Deadline 9 Submission

This note represents a Deadline 9 submission, with detailed comment limited to aspects of Issue Specific Hearings, ISH2, ISH11, ISH12 and ISH 13.

Issue Specific Hearing 2 (ISH2) Onshore siting, design and construction

(FFT showing HVAC Sound Pressure Levels as function of frequency)

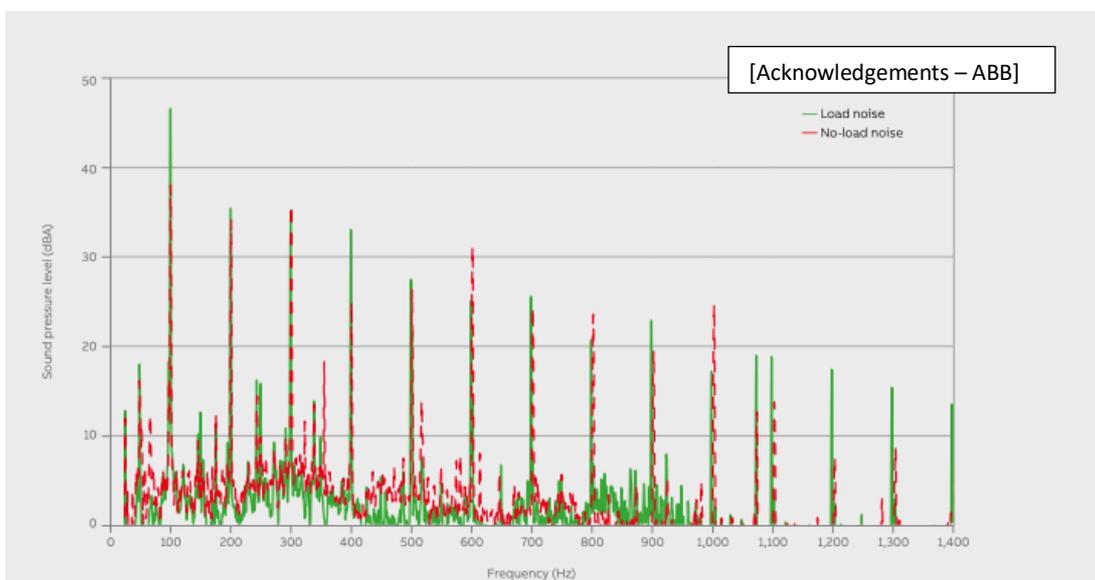
From the above it can be seen that the noise spectrum of a high power transformer is dominated by multiples of the First Harmonic (100 Hz), showing distinct lines at 100Hz, 200Hz, 300 Hz, etc. The Applicant's portrayal of acoustic signature is in part flawed, because the Applicant has adhered rigidly to the "standard" spectrum set out in BS 4142, ie 63Hz, 125 Hz, 250 Hz, 500 Hz, 1 kHz, 2 kHz, 4 kHz and 8 kHz, which would be appropriate if the noise signature in question originated in a highly de-correlated source like motorway traffic.
